**CITY OF SACRAMENTO**  
1231 I Street, Sacramento, CA 95814

**Permit No: 0103761**  
**Insp Area: 4**

**Nature of Work: NEW 13 X 15 FT PATIO COVER IN REAR**

**CITY OF SACRAMENTO DEVELOPMENT SERVICES DIVISION  
PLANNING AND ZONING INFORMATION REQUEST**

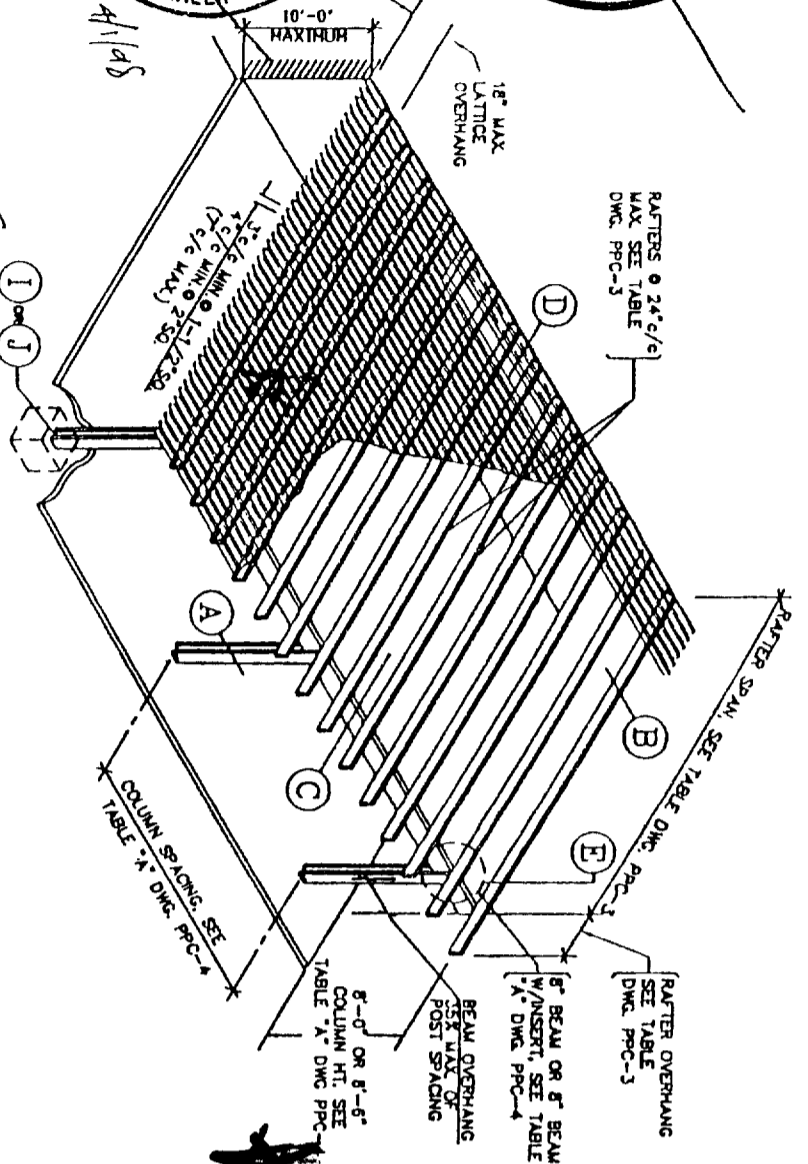
Comments: meets setback requirements, but exceeds lot coverage by 250 s.f.; 40% of 7642 s.f. lot area = 3057 s.f. minus house (footprint) & garage leaves 200 s.f. + allowance of 100 s.f. toward accessory struct. = 300 s.f. total allowed for patio cover

Are There Any Planning Issues?: (circle one) **YES** NO

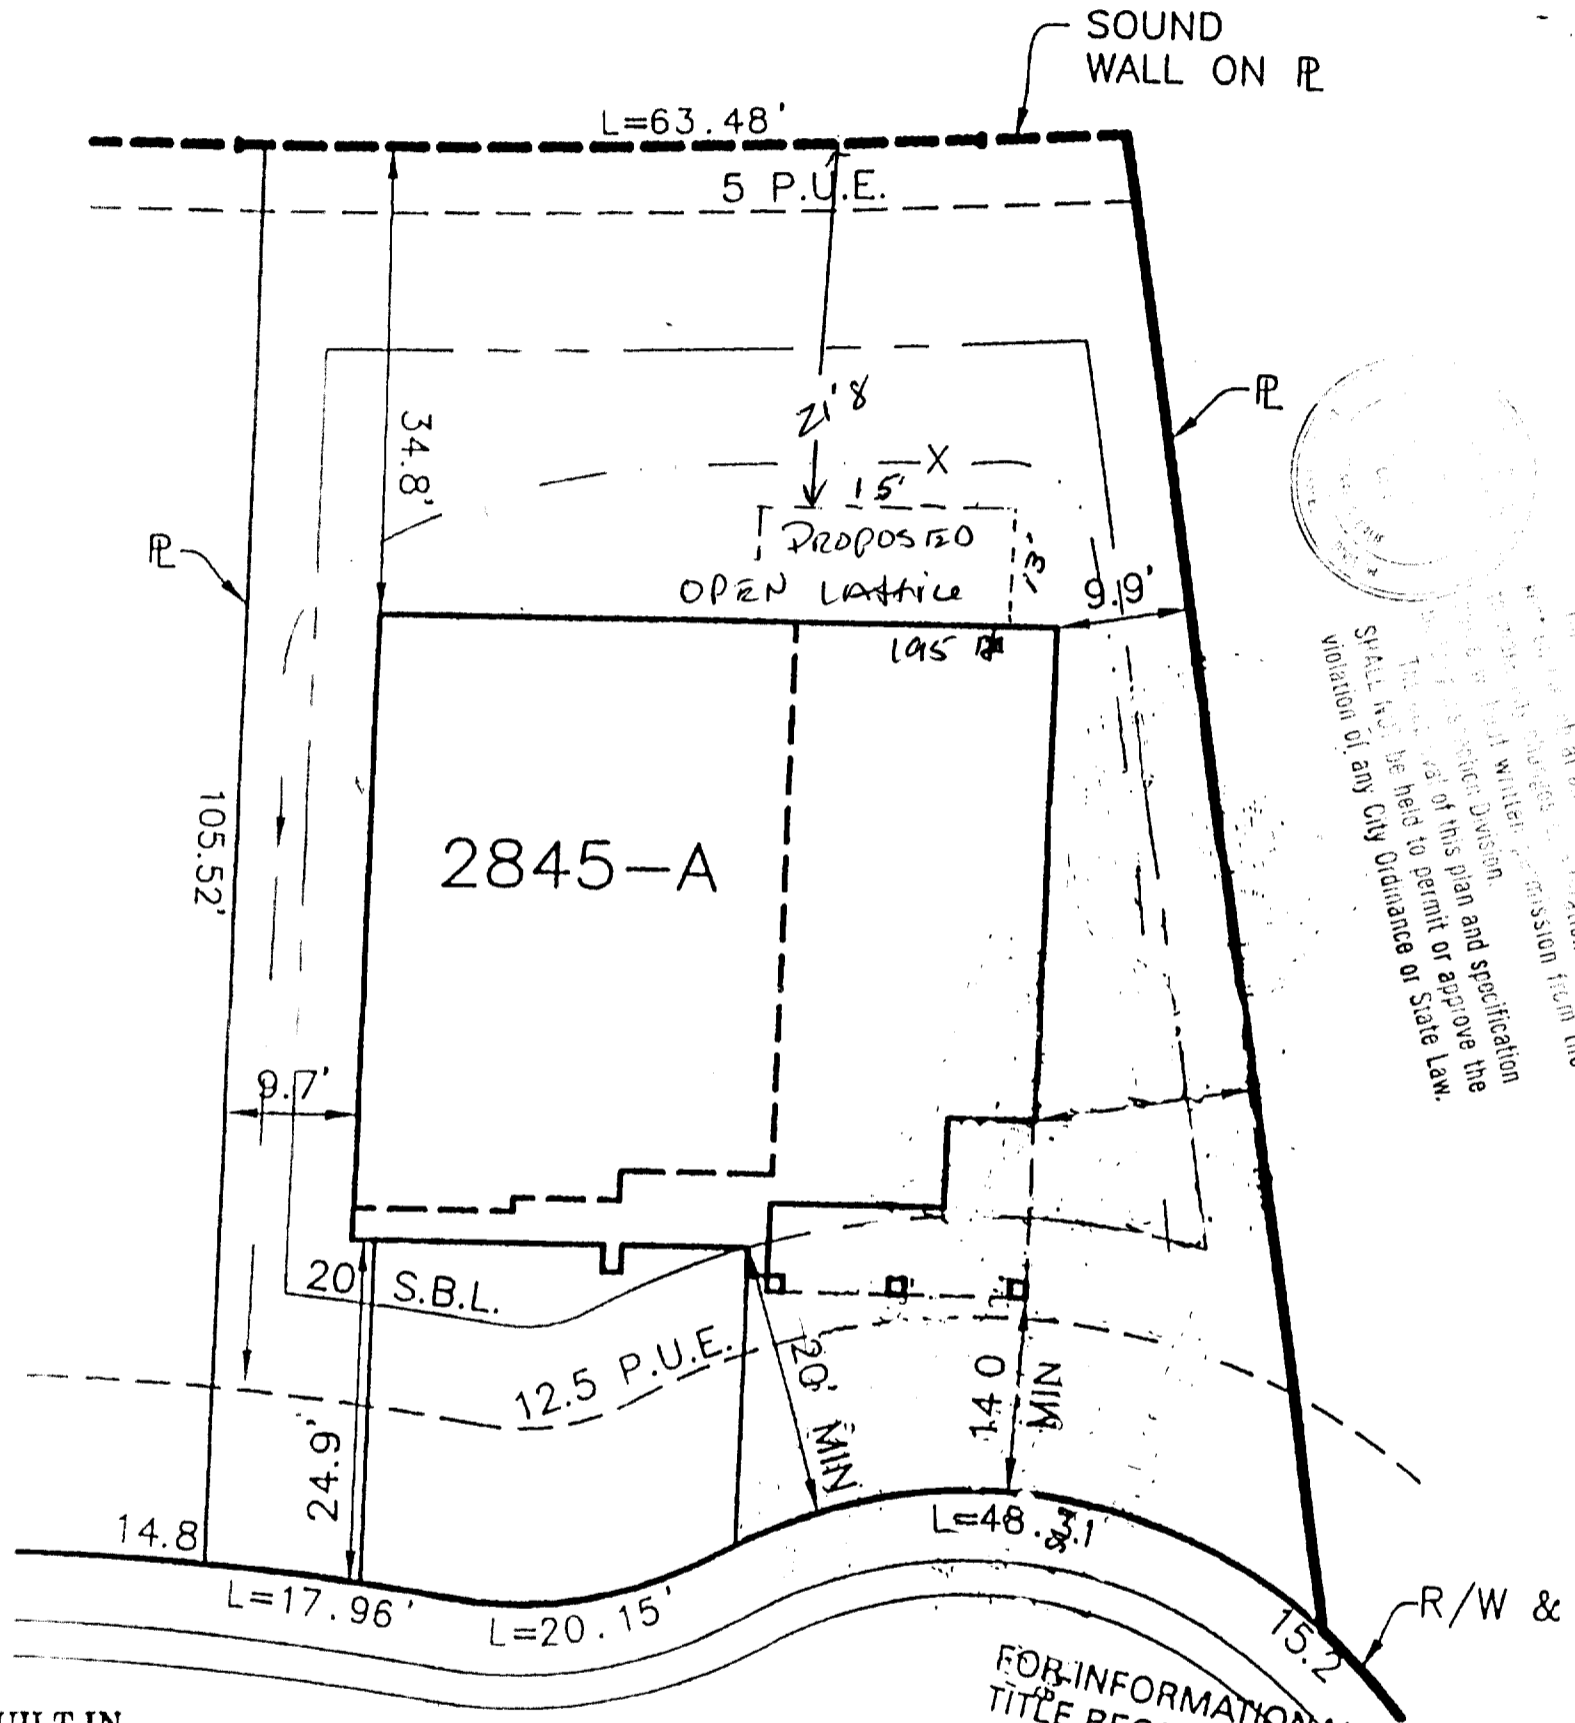
*See pink slip*

*for planning approval*

*plan checked by B. Lawrence*
